REPORT AMENDED BY STAFF 3-4-87
CIT PLANNING COMMISSION

APPLICATION: A. Plan Review of a 2,920 sq. ft., 74 seat fast-food restaurant with one drive-through window on 0.9+ acres in the General Commercial-Review (C-2-R) Zone

PROPOSAL: The applicant is requesting the necessary entitlements to construct a Kentucky Fried Chicken fast-food restaurant with a drive-through window

Subject: Special permit to develop a 2,920 sq. ft. restaurant with one drive-up window
(P87-039)

SITE PLAN

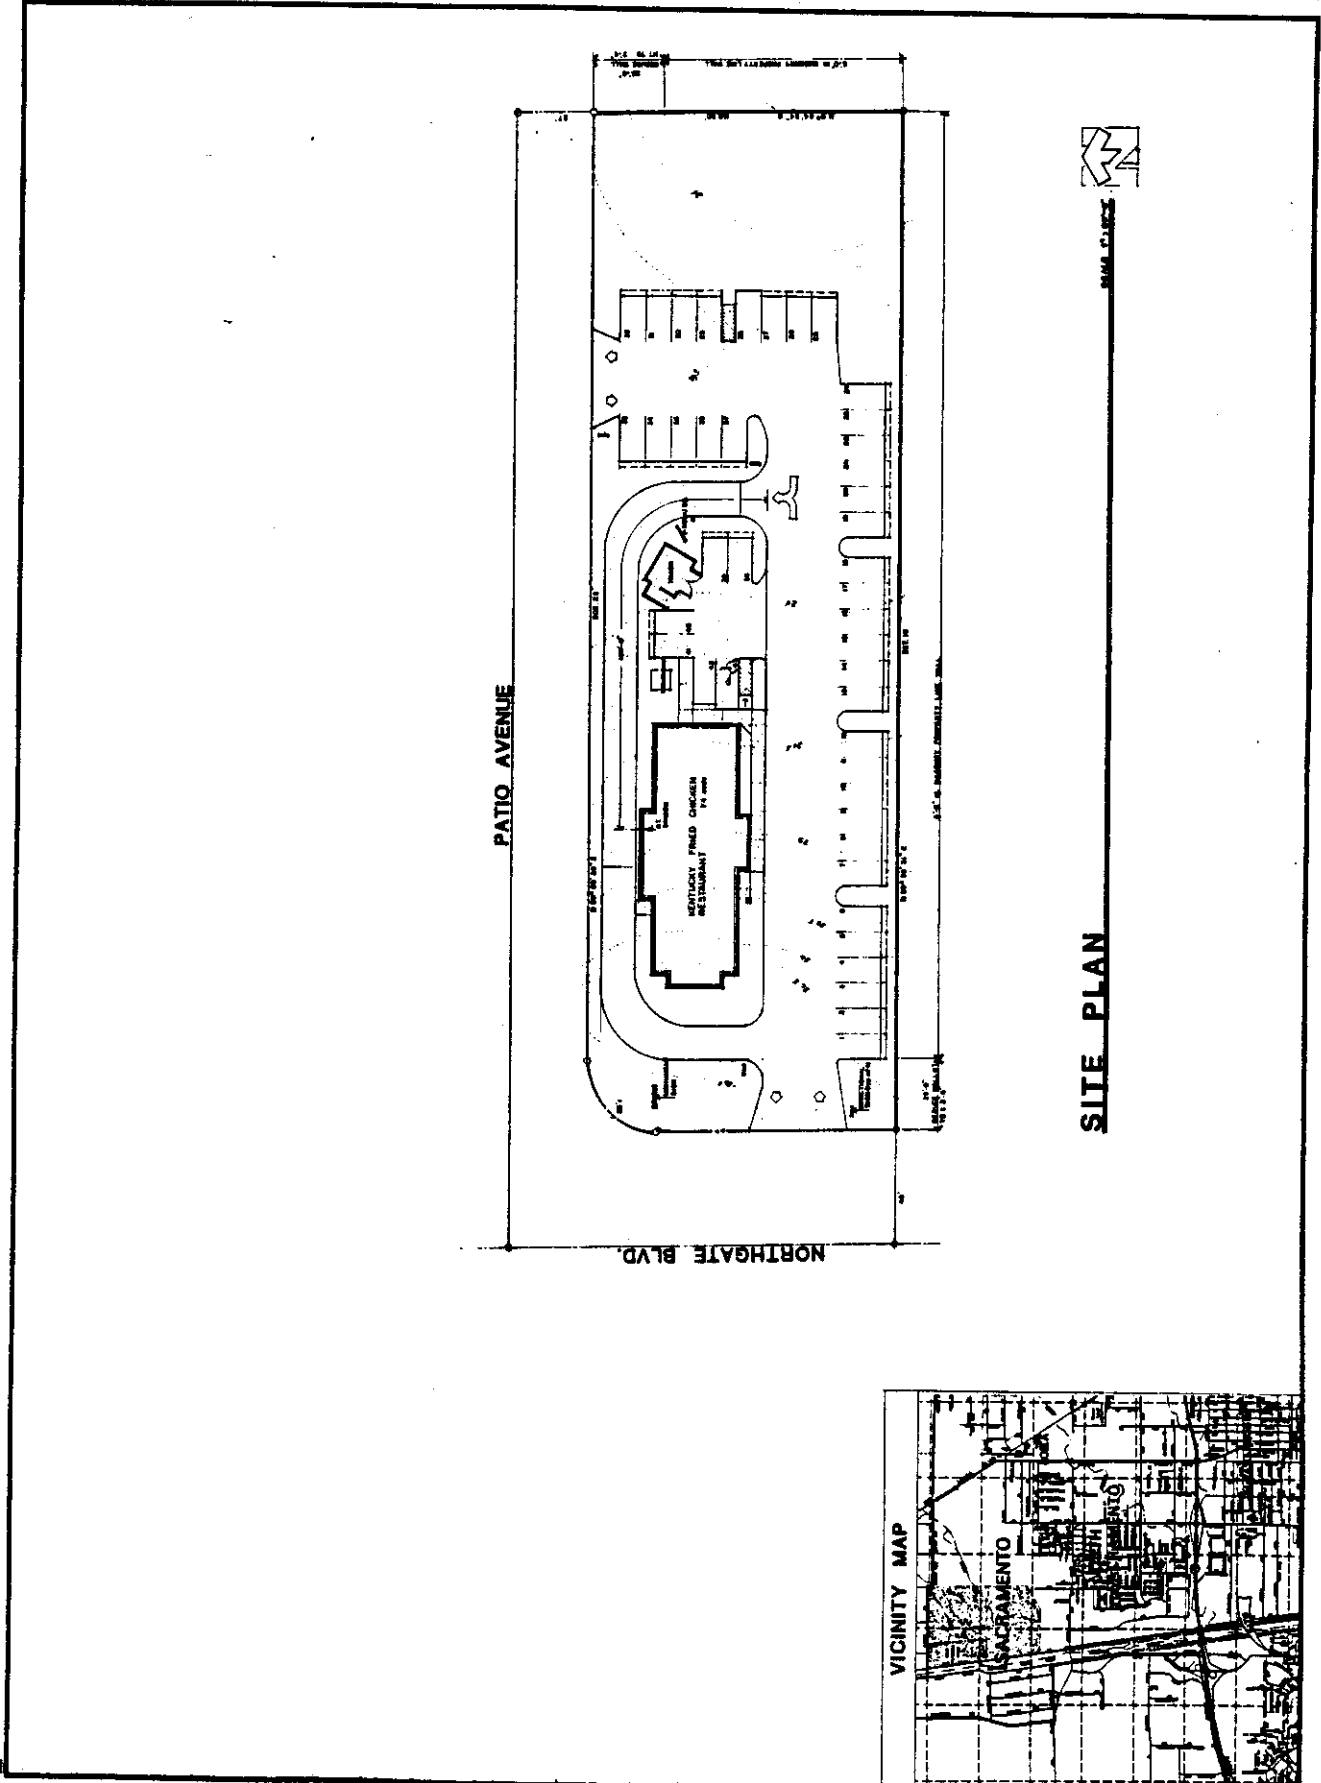
2. **Trash Enclosure:** The applicant's site plans show a trash enclosure. Staff recommends that the trash enclosure comply with the attached Trash Enclosure Guidelines (Exhibit A).

3. **Walls:** A 6-foot high solid wall is shown along the south and east property line. The method of construction and type of wall appears to be masonry block on a concrete foundation. Staff recommends that the wall be constructed of a decorative material and color compatible with the restaurant's design. The wall shall observe the height limits within the 25-foot setback area off Northgate Boulevard and Patio Avenue.

4. **Driveway for Drive-Through Window:** Staff has discussed with the applicant a potential conflict with pedestrian traffic coming off Patio Drive across the drive-through driveway to the north door. The office/warehouse development and future use by Golden Gate University to the north of Patio Avenue may create an increase in pedestrian traffic across the drive-through driveway. Staff recommends that the applicant revise his site plan to provide intensive landscaping along Patio Avenue in the 5-foot planter adjacent to the sidewalk to deter through traffic. Another alternative is to provide a walkway with railing to prevent access adjacent to the north side of the building leading from the Northgate Boulevard.

5. **Utility Transformer and Meters:** Staff recommends that any utility distribution facilities be screened so to not be visible off-site. The SMUD transformer proposed between the building and trash enclosure shall be screened with materials or landscaping compatible with the building.

1. **South Property Line Wall:** Staff notes that deciduous trees are shown along the landscape area adjacent to the south property line. Staff recommends use of evergreen trees for shading adjacent to the residentially zoned property in place of the deciduous trees. It should be noted the landscape planter adjacent to the south property line will require an increase in width from 5 feet to 6 1/2 feet allowing 6 inches for a wall, 2 feet for vehicle overhang and 4 feet of clear, unobstructed landscaping between the wall face and vehicle overhang area.

3. **Curb and Wheel Stops:** The applicant shows the use of 6 inch concrete curb with vehicle overhang. Staff recommends that no portable concrete wheel stop be used on the site and that 6-inch concrete curb be used adjacent to all landscape areas.

City Code requires one Class I bicycle parking facility for each 25 required parking spaces for commercial uses. The applicant is required to provide 28 spaces and shows 43 including one handicapped. The revised site plan shall show the location of a bicycle storage facility.

1. Increased landscape strip along the south property line to 6 1/2 feet. These may require redesigning stalls 1 to 12 to a 60 degree angle.
2. Eliminate the 2 stalls, number 32 and 33 closest to Patio Avenue at the driveway so no vehicles back into traffic entering or exiting the site. The total area free of parking should be 20-foot deep as measured from the Patio Avenue right-of-way property line. Staff recommends landscaping in the area which does not create a visibility problem.
3. The revised site plan shall show all dimensions of driveways, parking spaces, building setbacks and landscaped areas. Due to the limited area of the site, dimensions are necessary to determine viability of the site layout.

2. Six-foot high decorative walls shall be shown on a revised site plan adjacent to residential zones compatible in color with the restaurant.
3. All driveways shall be designed to City standards for commercial driveways. All improvements to the public right-of-way shall be reviewed and approved by the City Engineer's Office.

4. The trash enclosure shall be designed according to the attached trash enclosure guidelines (Exhibit A).
5. The applicant shall restrict access off Patio Avenue across the drive-through driveway by use of intensive landscaping or providing railing or barrier along the north building elevation opposite the north doorway. An "Exit Only" doorway may be most appropriate with no external door hardware.

6. The eastern portion of the lot shall be landscaped with grass, irrigated and maintained in a litter free condition.
7. The parking lot shall delete stalls 32 and 33 closest to Patio Avenue so that a minimum of 20 feet of vehicle clear area is established off Patio Avenue. Landscaping shall be low profile so to not provide visibility problems.

8. Parking lot shall comply with the 50 percent shading requirement. A minimum 4-foot planter strip and 2 additional feet of planter for vehicle overhang shall be provided adjacent to the wall.

ENTER/EXIT SIGNS

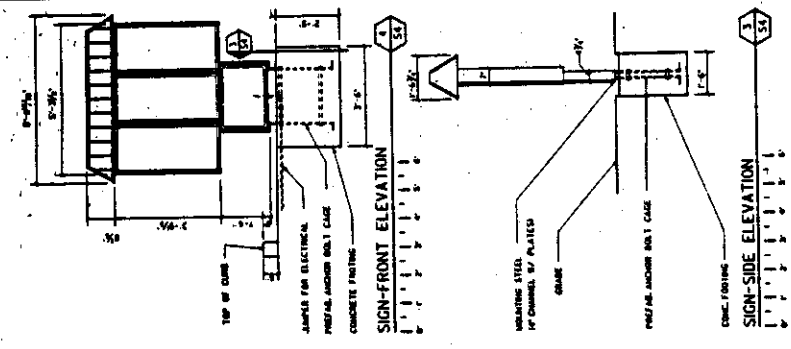
3. Welcome/Enter Sign: The sign showing the logo and words "Welcome/Enter" should be downsized from 5-foot high, 3 1/2-foot wide size to a more modest size of no greater than 4-square feet of sign area and 4 feet in height. The signs should be set back more than 10 feet from the public right-of-way. The words "Welcome/Thank You" and the logo are not allowed as part of the directional sign. Staff recommends that the applicant submit a signage program reflecting all above concerns for review and approval by the Planning Director prior to issuance of sign permits.

16. The one way only drive-through exit shall be clearly marked so the public does not mistake the driveway for an entrance. The sign shall be approved by the Planning Director as part of the sign program.
17. The loudspeaker used by the drive-up window shall not be audible to adjacent residential windows.
18. The revised site plan shall show all dimensions.
19. The existing single-family dwelling shall be offered for relocation 60 days prior to demolition. Trees shall be retained if possible on the landscape plan.

DRIVE-THRU MENU BOARD

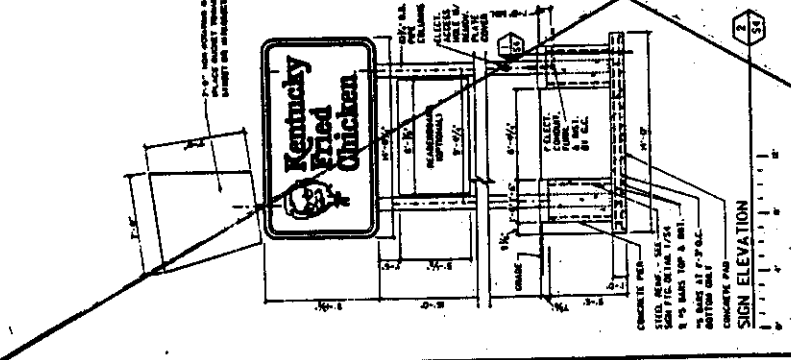
The drive-through window requires an external speaker unit. Staff recommends that the volume on the loudspeaker be controlled so to not be audible to adjacent residentially zoned property. The menu board may required readjustment to face northward so that the loudspeaker projects to the north and not east as shown.
